Work Order ID 151912

Item Name: AS350/AS355 Quick Release Heli-Utility-Basket™ Long, Heavy Duty Lid

DART SERVICE INSTRUCTION

TO AMEND INSTALLATION INSTRUCTIONS D350-607-3 Rev.D,
INSTALLATION INSTRUCTIONS D350-607-4 Rev. C AND
INSTRUCTIONS FOR CONTINUED AIRWORTHINESS ICA-D350-607 REV. 6

FIGURE 1: INSTALLATION OF D4775-041 FWD STRUT

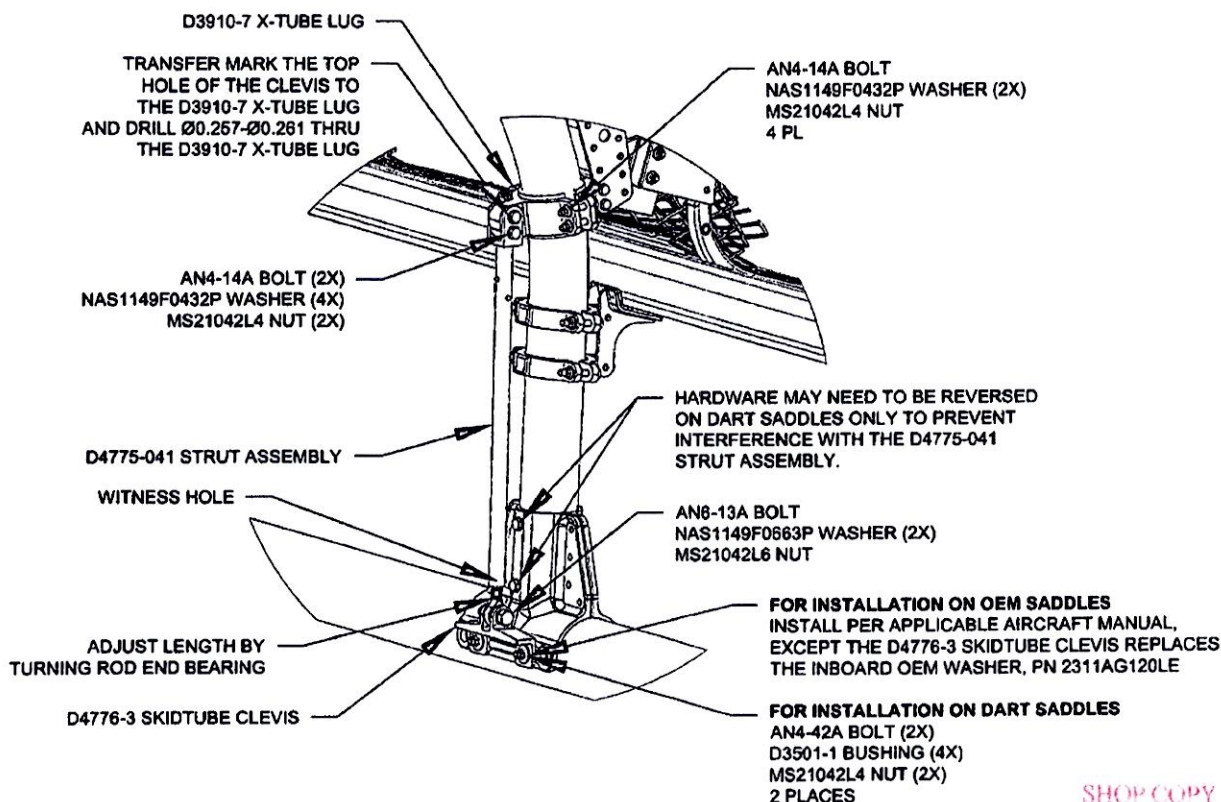
Modify the quantities for D3910-5 and add D3910-7 as follows:

Install the D350-607-501 Conversion Kit, D350-607-511 Quick Release Mounting Kit or D350-607-431 Strut retrofit kit per Installation Instructions D350-607-3 Rev. D or D350-607-4 Rev. C. While installing the Forward Strut perform the following:

- 3.1 Substitute the Forward Lower D3910-5 X-Tube Lug with the D3910-7 X-Tube Lug as shown in Figure 1.
- 3.2 Install the forward D4775-041 Strut Assembly. Transfer mark from the upper hole on the clevis of the D4775-041 Strut Assembly to the D3910-7 X-tube Lug and drill thru the lug $\varnothing 0.257$ - $\varnothing 0.261$ as shown in Figure 1. Touch up chemical conversion coating per MIL-DTL-5541. Check the witness holes located at the bottom end of the D4775-041 Strut Assemblies to ensure that the thread from the rod end extends past the witness hole.
Torque MS21042L4/-4 nuts to 50-70 in-lbs (5.7-7.9 N-m). Torque MS21042L6/-6 nuts to 160-190 in-lbs (18.1-21.5 N-m).
- 3.3 Complete the installation in accordance with Installation Instructions D350-607-3 Rev. D or D350-607-4 Rev. C.
